ROCKY FLATS SITE

REGULATORY CONTACT RECORD 2015-04

Purpose: Mound Site Plume Treatment System (MSPTS) Reconfiguration Conceptual Approach

Figure 1

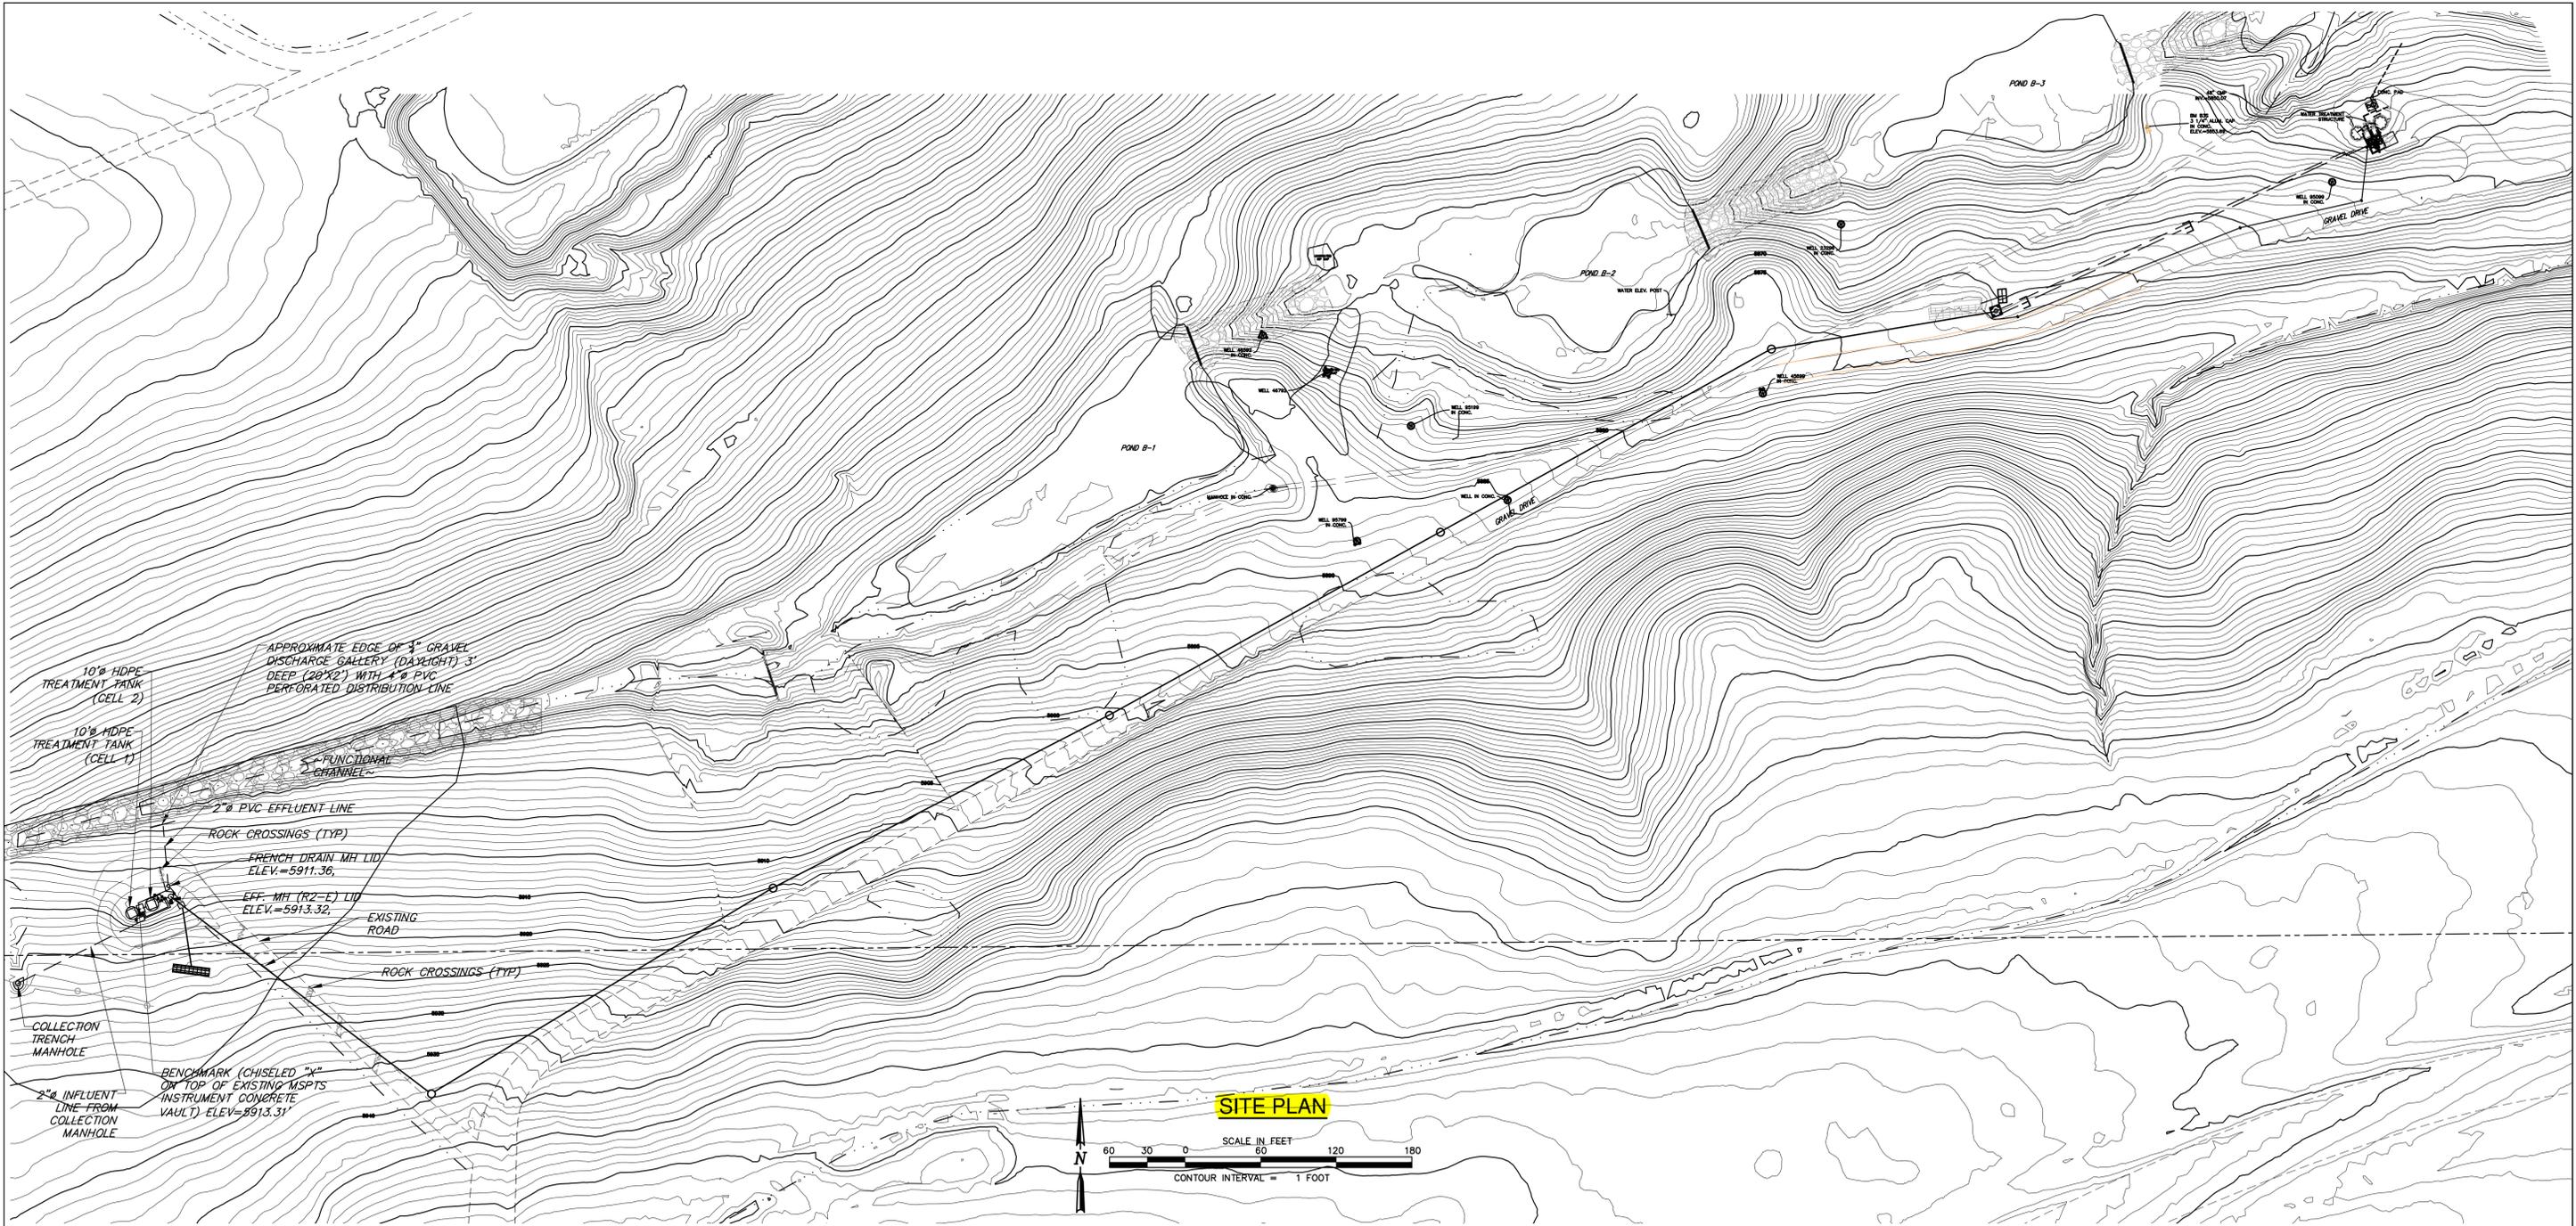
A conceptual approach has been developed and discussed among the RFLMA parties. This approach includes routing the MSPTS influent to the ETPTS air stripper; see Figure 1. The existing MSPTS tanks will initially be maintained and modified for optional water storage. The existing MSPTS effluent manhole will be replaced with a lift station and pump; water collected by the MSPTS will be pumped from this lift station to the ETPTS influent manhole. The combined MSPTS and ETPTS influents would then flow to the ETPTS influent tank and be pumped to the ETPTS air stripper in batches, just as is currently done with ETPTS influent alone. Additional solar power, piping, valves, instrumentation, and other necessary components would be installed to support this approach. Minor modifications to RFLMA Attachment 2 to reflect changes in MSPTS sampling locations have also been identified.

Resolution: It was agreed that DOE will prepare engineering designs for treating the MSPTS influent using the ETPTS air stripper. The RFLMA parties will consult in a timely manner on proceeding with the MSPTS reconfiguration to allow further planning and implementation as part of the MSPTS ZVI media removal project. Approval of the reconfiguration and of any required Soil Disturbance Review Plan for the work will be documented in a subsequent contact record.
